STATE OF HAWAII
DEPARTMENT OF LAND AND NATURAL RESOURCES
COMMISSION ON WATER RESOURCE MANAGEMENT
P.O. BOX 621
HONOLULU, HAWAII 96809

STAFF SUBMITTAL

August 29, 2019
Wailuku, Hawaii

Approval of a Stream Diversion Works Permit Application (SDWP.4950.6)
by East Maui Irrigation Company to Remove and Abandon 11 Diversions (Category 3)
on the Honopou, Hanehoi (Puolua), and Pi'ina'au (Palauhulu) Streams,
East Maui Irrigation System, East Maui, Hawai'i; TMK: Various

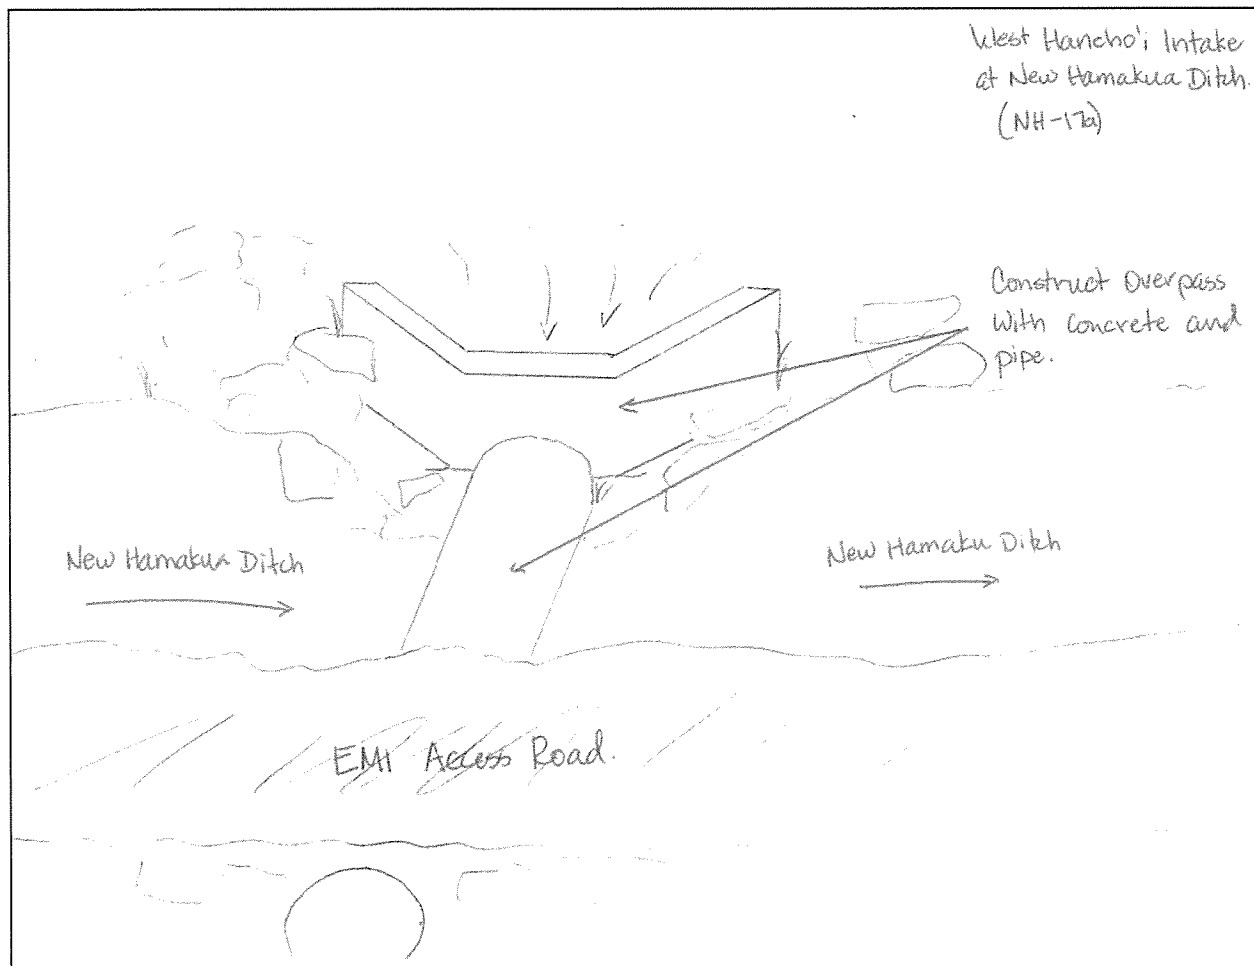
DAR Comments: The application seems to consistently use a stream overpass at various ditches without specifications or analysis of high flows. It appears that the Lowrie Ditch is being given priority over the Stream. EMI's proposed modifications maintains the Lowrie ditch and access

FWS Comments: Native gobies move up stream corridors for reproduction. However, they will not pass through dark spaces (pipes). We recommend keeping diversions open as much as is feasible to accomplish the restoration of stream flow. Two listed animal species have the potential to either be in or fly through the vicinity of the project area - the Pacific Hawaiian damselfly (*Megalagrion pacificum*) and the Hawaiian hoary bat (*Lasiurus cinereus semotus*). Both are threatened by predation and habitat loss. We recommend not to disturb, remove, or trim woody plants greater than 15 feet tall during the birthing and pup-rearing season (June 1 – Sept 15). The proposed action includes activities at diversion NH-17a where the Pacific Hawaiian damselfly has been found previously. We recommend our Best Management Practices for Work in Aquatic Environments to minimize degradation of water quality and impacts to fish and wildlife resources. Permits are required for accurate surveys of this species so coordinate with us to develop and implement survey protocols.

Commission Staff Recommendations: The Commission staff, in order to more quickly effectuate the conveyance of water downstream, supports the construction of a stream overpass over the New Hamakua Ditch as proposed by EMI. Due to the small size of the tributary upstream of New Hamakua Ditch, it is anticipated that the tributary will not provide sufficient habitat for stream biota. Additionally, EMI intends to bury the pipe under the existing road makai and adjacent to the New Hamakua Ditch in order to maintain use of the road. Use of an open channel bypass, as alluded to by DAR and DOFAW, would require cementing the road to create a ford crossing and could result in downstream erosion of the road over time. The Commission staff does recommend that the pipe size should be no smaller than 24-inches to prevent clogging and potential maintenance issues.

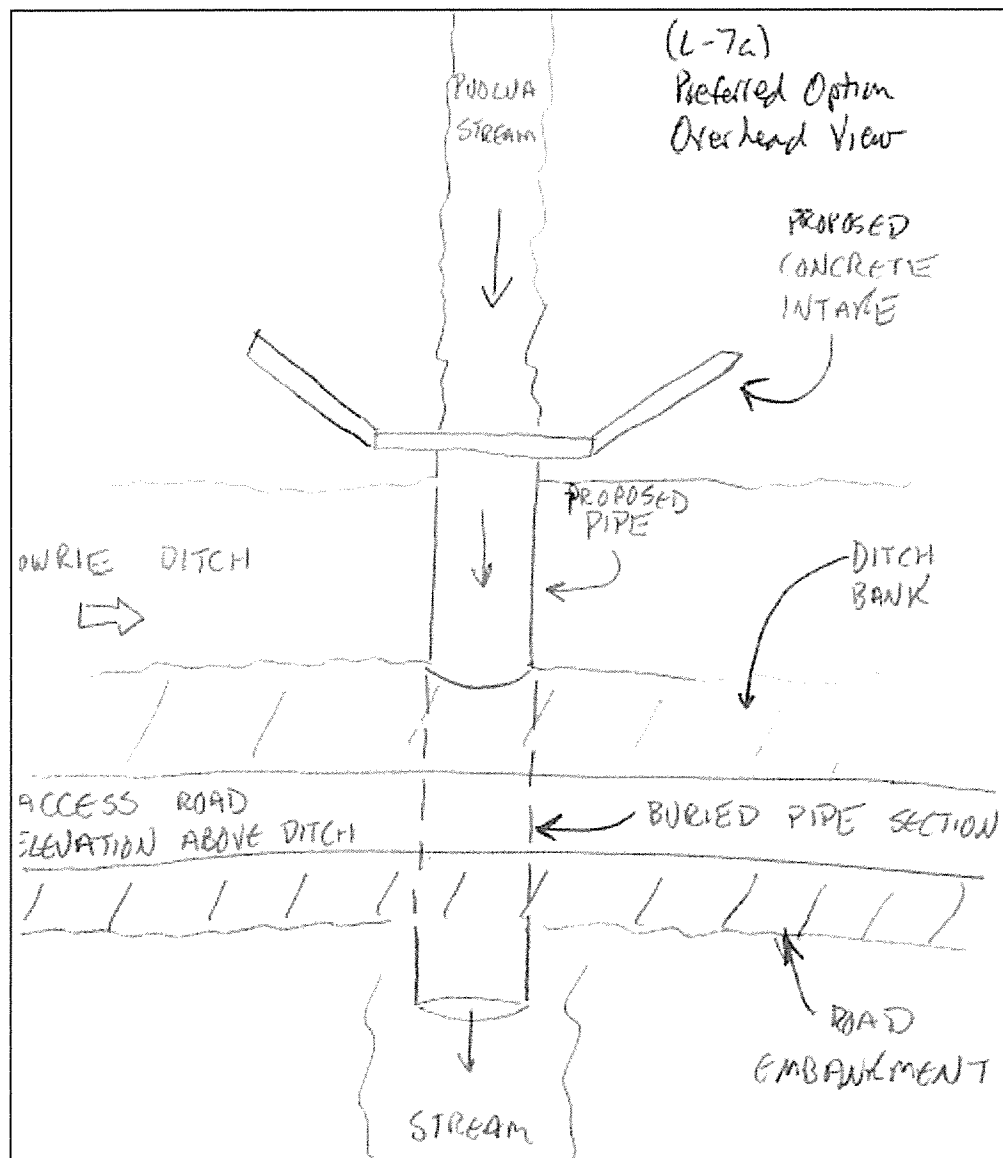
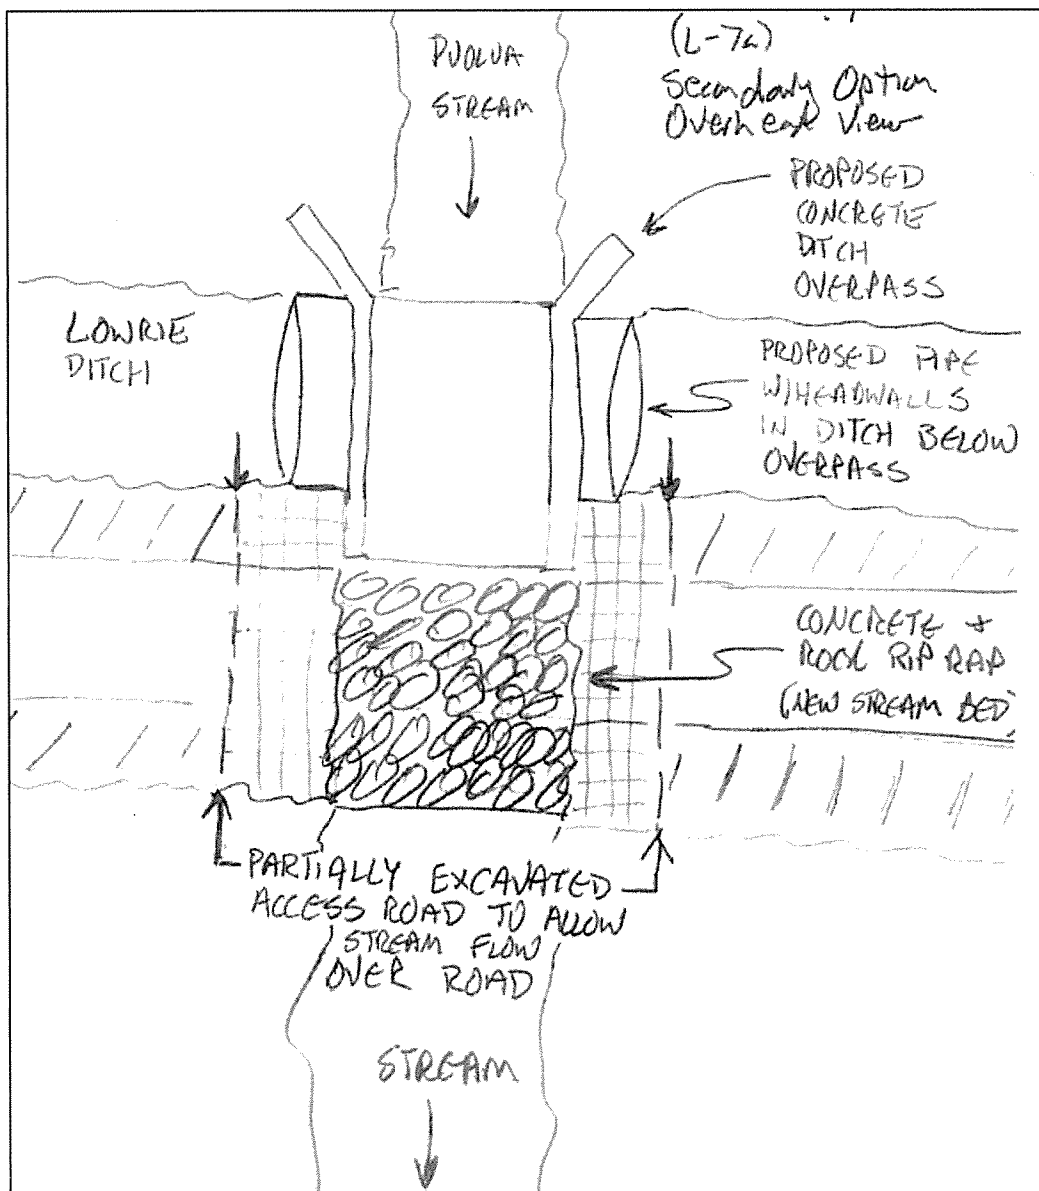
DAR Comments: The application seems to consistently use a stream overpass at various ditches without specifications or analysis of high flows. It appears that the Lowrie Ditch is being given priority over the Stream. EMI's proposed modifications maintains the Lowrie ditch and access road, not the natural stream. The typical stream overpass will allow most of the water during high flows to overflow into the ditch and only maintains a minimal flow from mauka to makai. The pipe transporting water downstream pours into the lower stream. If water is allowed to flow out of the pipe, migrating 'ōpae or 'o'opu cannot jump into the pipe. The proposed concrete pipe will not help upstream migration of native animals. DAR also has maintenance and inspection concerns. This appears to be wider and may have higher storm flows. It appears that a box culvert for the ditch might be easier than trying to build a stream overpass. Prefers Fig. 8b and supports natural stream bottoms.

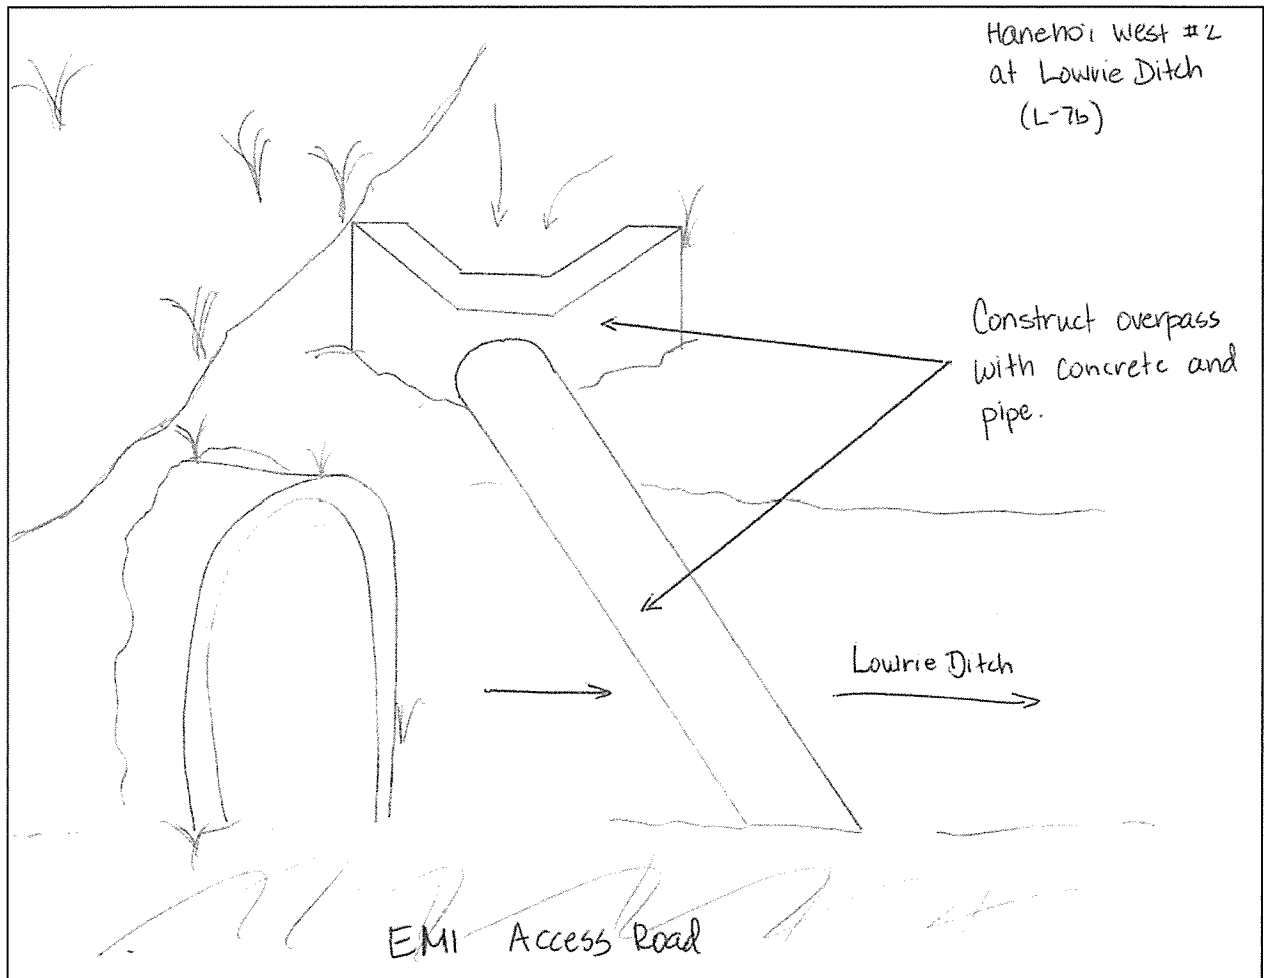
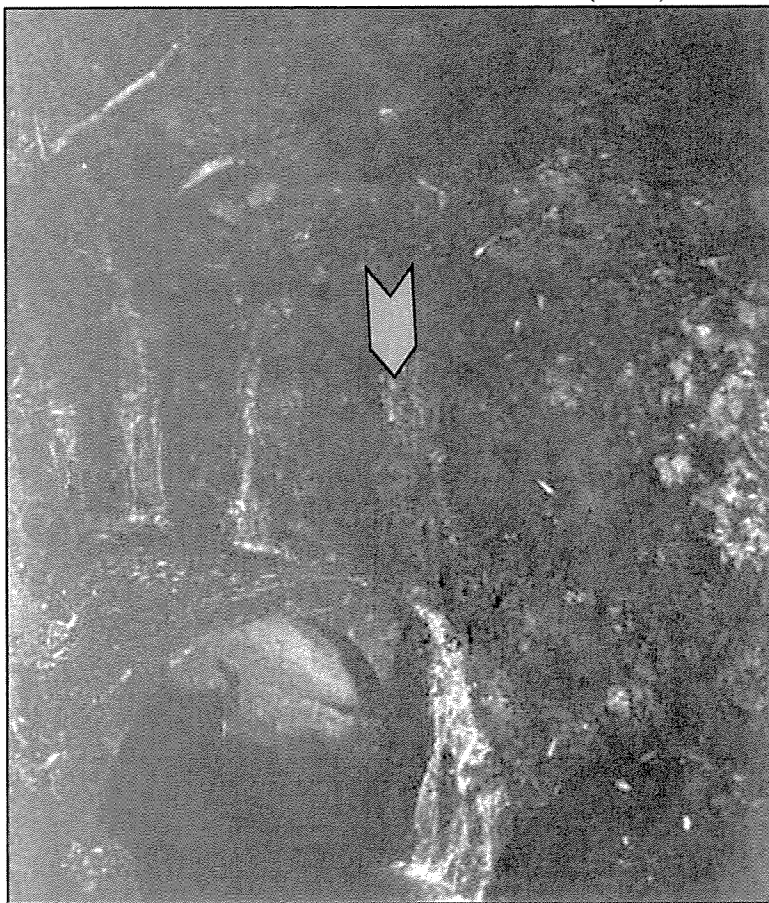
DAR Comments: The application seems to consistently use a stream overpass at various ditches without specifications or analysis of high flows. It appears that the Lowrie Ditch is being given priority over the Stream. EMI's proposed modifications maintains the Lowrie ditch and access road, not the natural stream. The typical stream overpass will allow most of the water during high flows to overflow into the ditch and only maintains a minimal flow from mauka to makai. The pipe transporting water downstream pours into the lower stream. If water is allowed to flow out of the pipe, migrating 'ōpae or 'o'opu cannot jump into the pipe. The proposed concrete pipe will not help upstream migration of native animals. DAR also has maintenance and inspection concerns. Not enough information.

DOFAW Comments: As noted previously, with general concerns:

1. Walls, structures, or channels that alter the natural course of the stream can restrict flow. Stagnant waters become breeding sites for mosquitoes and are vectors for introduced diseases and are a major threat to native forest birds.
2. The use of pipes or other structures obstruct fish passage.
3. Stream alteration can result in high levels of erosion and adversely affect water quality.
4. Abandonment of accessory structures, including pipes, pump houses, intakes, mechanisms, or other items no longer in use, may become derelict if not maintained.

FWS Comments: Native gobies move up stream corridors for reproduction. However, they will not pass through dark spaces (pipes). We recommend keeping diversions open as much as is feasible to accomplish the restoration of stream flow. Two listed animal species have the potential to either be in or fly through the vicinity of the project area - the Pacific Hawaiian damselfly (*Megalagrion pacificum*) and the Hawaiian hoary bat (*Lasiurus cinereus semotus*). Both are threatened by predation and habitat loss. We recommend not to disturb, remove, or trim woody plants greater than 15 feet tall during the birthing and pup-rearing season (June 1 – Sept 15).

Commission Staff Recommendations: The Commission staff, in order to more quickly effectuate the conveyance of water downstream, supports the construction of a stream overpass over the Lowrie Ditch as proposed by EMI. Due to the small size of the tributary upstream of Lowrie Ditch, it is anticipated that the tributary will not provide sufficient habitat for stream biota. Additionally, EMI intends to bury the pipe under the existing road makai and adjacent to the Lowrie Ditch in order to maintain use of the road. Use of an open channel bypass, as alluded to by DAR and DOFAW, would require cementing the road to create a ford crossing and could result in downstream erosion of the road over time. The Commission staff does recommend that the pipe size should be no smaller than 24-inches to prevent clogging and potential maintenance issues.

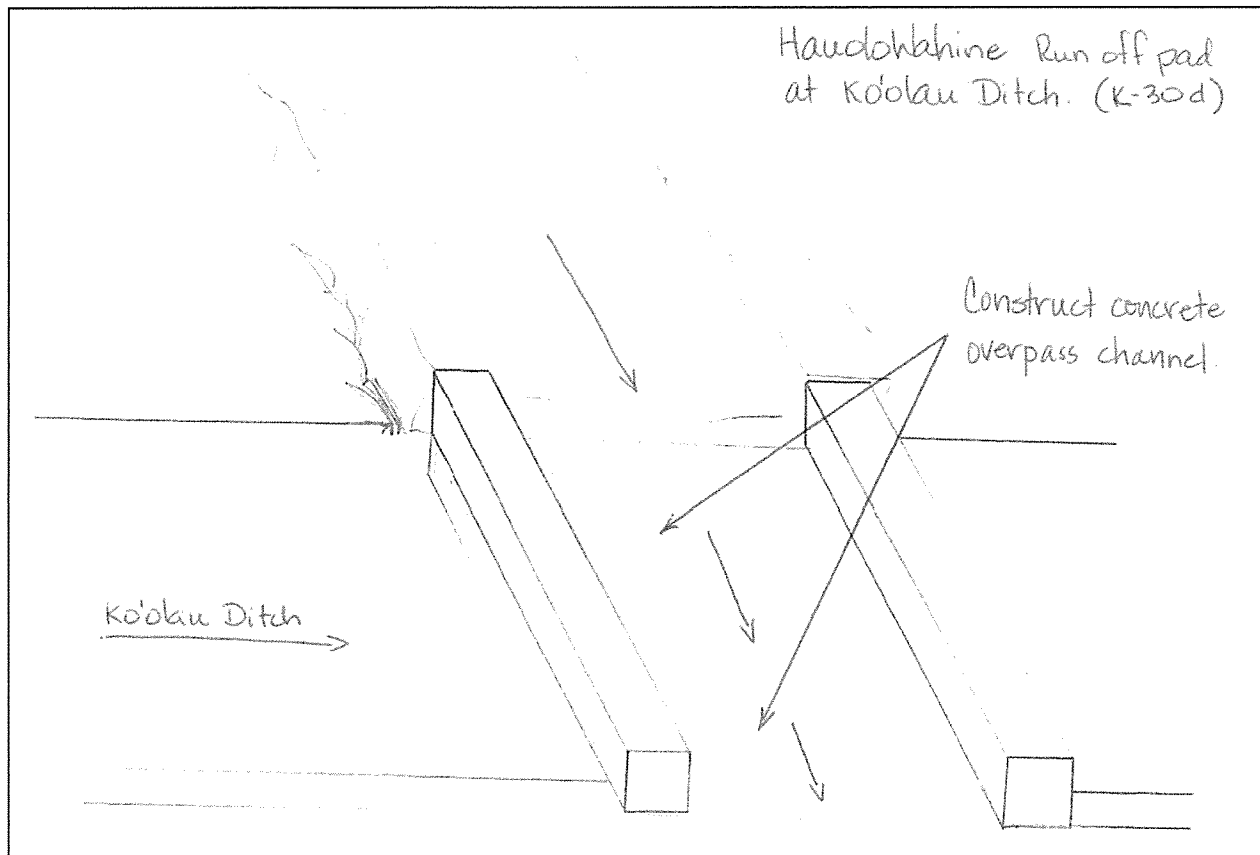
DAR Comments: Not enough information regarding site.

FWS Comments: Native gobies move up stream corridors for reproduction. However, they will not pass through dark spaces (pipes). We recommend keeping diversions open as much as is feasible to accomplish the restoration of stream flow. Two listed animal species have the potential to either be in or fly through the vicinity of the project area - the Pacific Hawaiian damselfly (*Megalagrion pacificum*) and the Hawaiian hoary bat (*Lasiurus cinereus semotus*). Both are threatened by predation and habitat loss. We recommend not to disturb, remove, or trim woody plants greater than 15 feet tall during the birthing and pup-rearing season (June 1 – Sept 15).

10. Hauolowahine Small Intake at Hauolo Ditch (K-30b): Remove stone and concrete dam as proposed by EMI.
 11. Hauolowahine Runoff Pad at Koolau Ditch (K-30d): Construct a stream overpass over the Lowrie Ditch as proposed by EMI, consisting of wing walls and a concrete pipe no less than 24-inches in diameter. The majority of the structure will span the ditch and access road, with a portion of the pipe buried under the access road. Work may require the use of a small excavator operating from the stream bank.

Figure 1. Wailoa ditch intake (W-22). Collection grate (left) and accessory pipes (right).

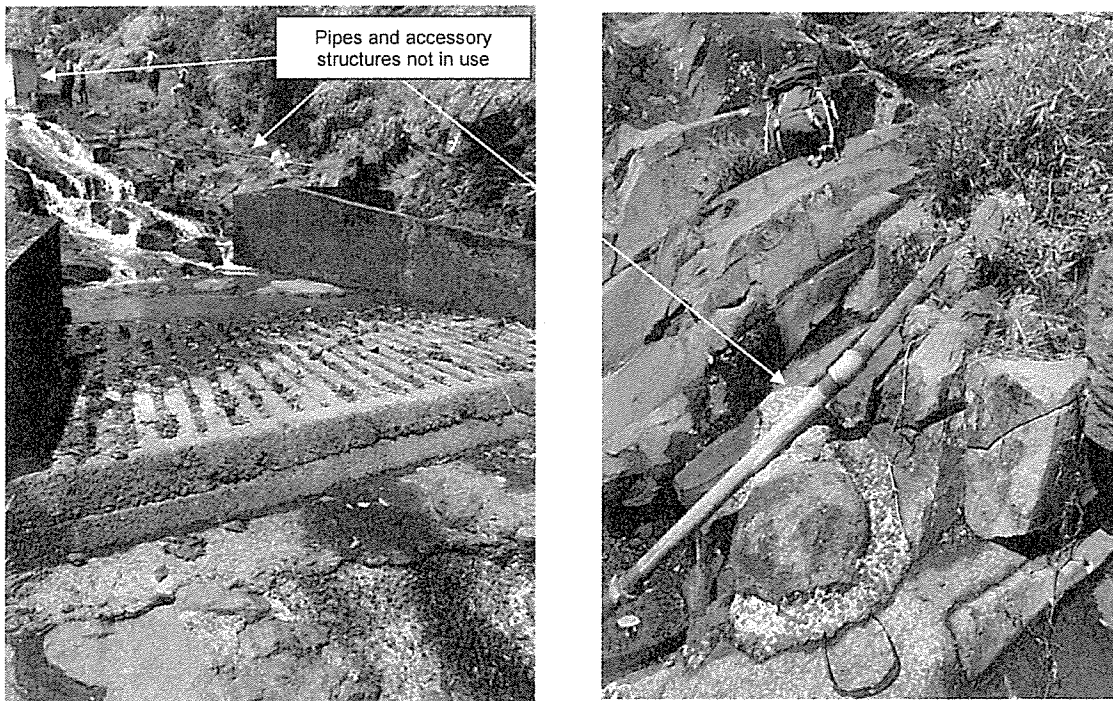
- a) Honopou is a perennial stream approximately 10 miles in length, originating in the Koolau Forest Reserve. The stream is reported by DAR to have native macro faunal diversity > 5 species, including native fish, crustaceans, and insects.
- b) Diversions
 - i) Wailoa ditch intake (W-22)
 - (1) Comments
 - (a) Diversion located in Koolau FR
 - (b) Grate captures water diverting it to the Wailoa ditch. Application proposes to seal grate to allow stream to flow. Accessory pipes were found in the diversion area.
 - (2) Recommendations
 - (a) Remove any pipes and accessories not in use.

Figure 2. Grate to be sealed (left). Accessory pump house above grate (right).

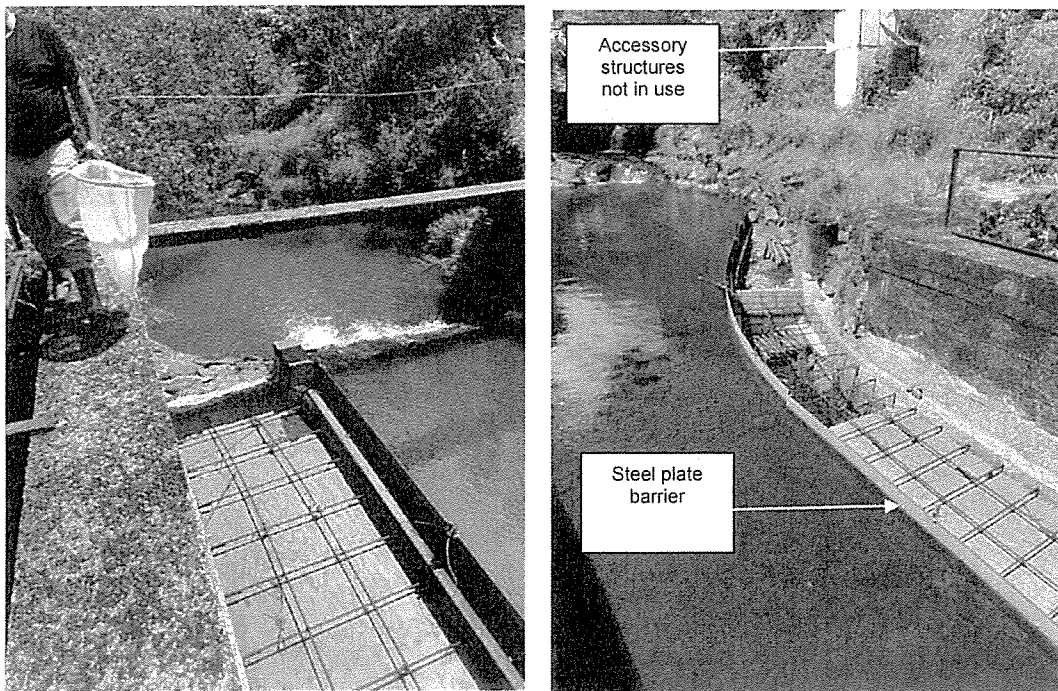
- ii) New Hamakua ditch intake (NH-22)
 - (1) Comments
 - (a) Diversion located in Koolau FR
 - (b) Grate on the west side of stream captures water for diversion. Application proposes to seal grate by filling with concrete.
 - (2) Recommendations
 - (a) After the grate is sealed, the steel plate should be removed and sufficient concrete should be used to ensure that stream flow is continuous over the grate area and water cannot become trapped and stagnant, creating breeding sites for mosquitoes.
 - (b) Remove any accessory structures not in use, such as the pump house shown in the figure below.

Figure 3. Road crossing tributary would appear to be prone to high levels of erosion.

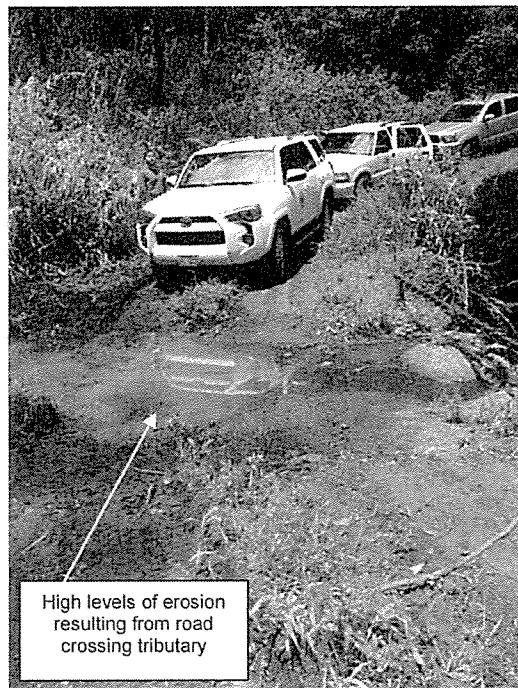
- iv) Wailole intake at New Hamakua ditch (NH-23)
 - (1) Comments
 - (a) This diversion is on EMI lands.
 - (b) The tributary feeds Honopou stream, which runs through the Koolau Forest reserve.
 - (c) The road crossing this tributary to Honopou stream appears to be prone to high levels of erosion.
 - (2) Recommendation
 - (a) Please assess erosion and impacts to water quality resulting from this location and consider installation of a concrete swale or other measures to control erosion.
